Applicant:	Jay Scott; Edina Apartments, LLC
Consultant:	Brian Gammon; Kimley-Horn
Project:	Pentagon Apartments Development
Location:	4911 West 77 th Street: Edina
Applicable Rule(s):	4 and 5
Reviewer(s):	LLH/BCO

General Background & Comments

Project Information							
Phase:	CD	Date:	06/16/2021				
Project No.:	160687017	Drawn By:	BPG				
Scale:	AS NOTED	Checked By:	WDM				
Pentagon Apartments Drawing Package Building Permit Submittal 19 November 21 Sheet Title							
GRADING AND DRAINAGE PLAN

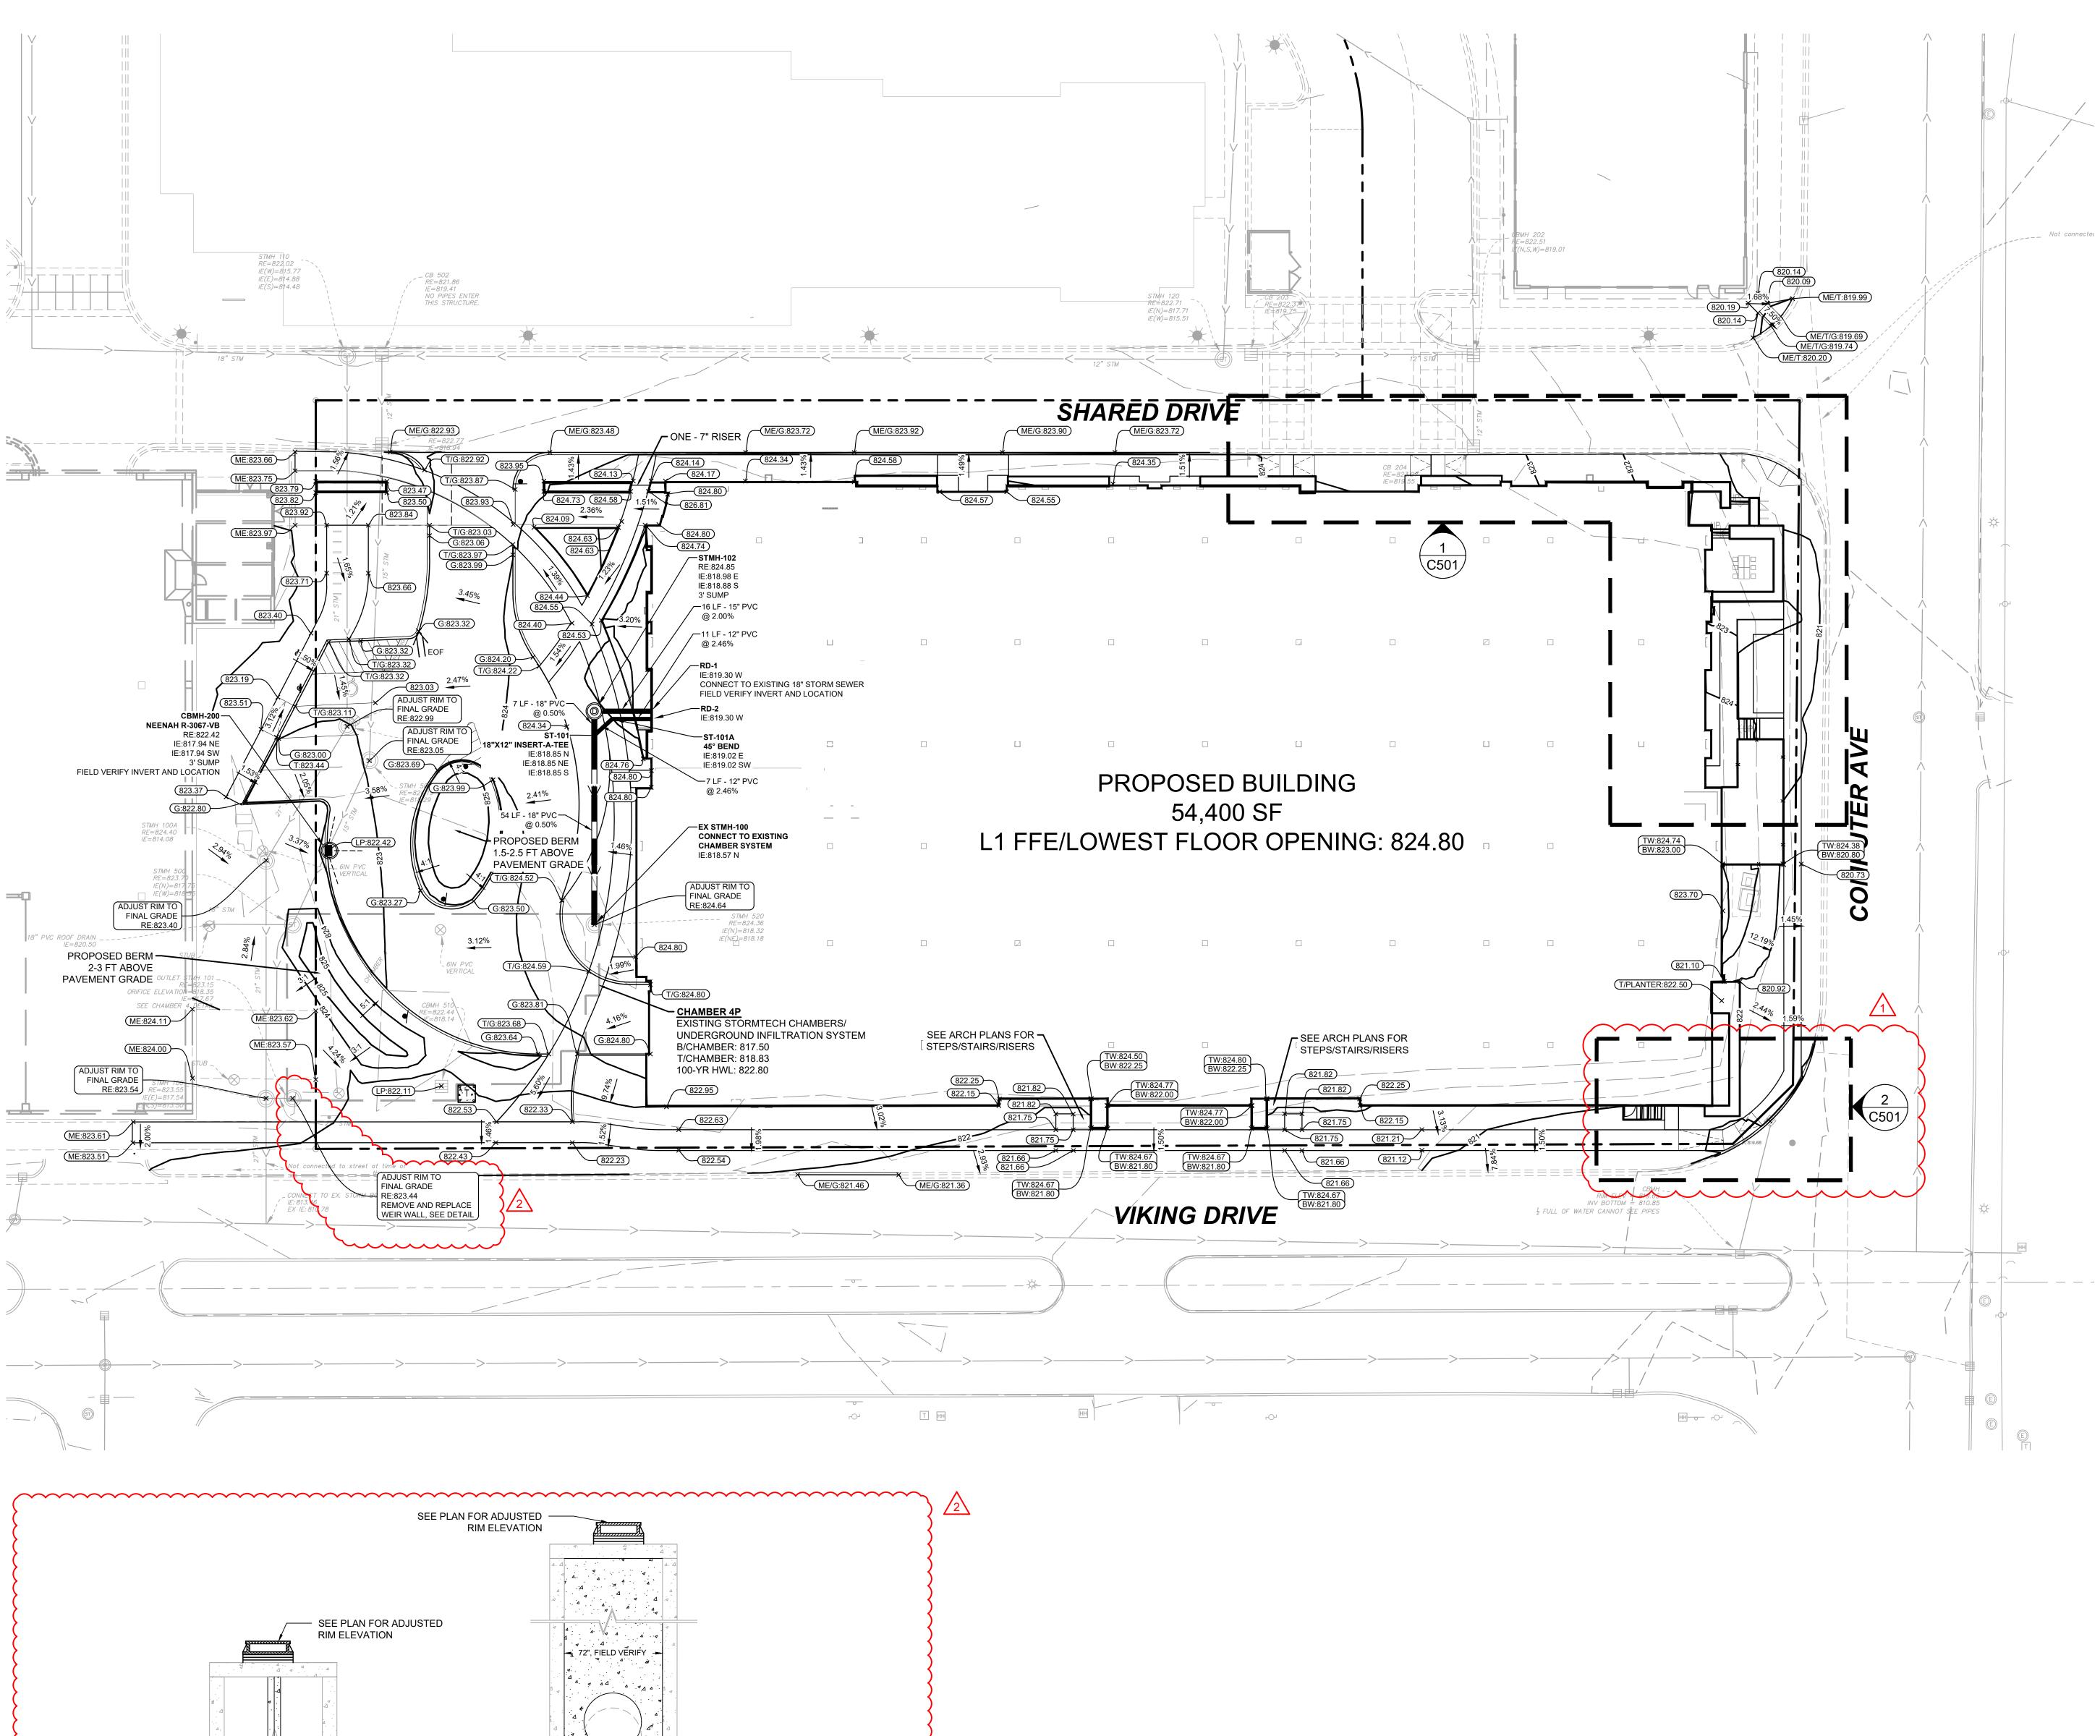
¹UGSWMF 4P was constructed in 2018 to provide volume retention, water quality management and rate control for Lot 3. As-built plans indicate a surveyed UGSWMF outlet control structure weir orifice elevation of 818.3 M.S.L. (818.8 M.S.L. approved). The Grading and Drainage Plan prepared by Kimley-Horn indicate the existing weir will be removed and replaced with a new weir wall with an orifice elevation of 818.8 M.S.L., complying with Rule 4.3.1a criteria and the Pentagon Village master plan.

A 5.2% decrease in impervious surface (4,440 square feet) from the Permit #2018-097 Lot 3 plan is proposed with the project. Information submitted indicates an additional 10,774 square foot decrease in impervious area tributary to UGSWMF 4P (within drainage area 13_2b outside of Lot 3). Until a development plan is received for the remaining lots within drainage area 13_2b, it is assumed the 10,774 square feet of impervious surface remains tributary to UGSWMF-4P. The proposed HydroCAD file must be revised to incorporate the 10,774 square feet of impervious surface assumed to be tributary to UGSWMF 4P.

Per Rule 4.5.8, an as-built drawing of the constructed Lot 3, Block 1 stormwater management facility conforming to the design specifications (including the proposed outlet control structure weir retrofit) is required to be provided.
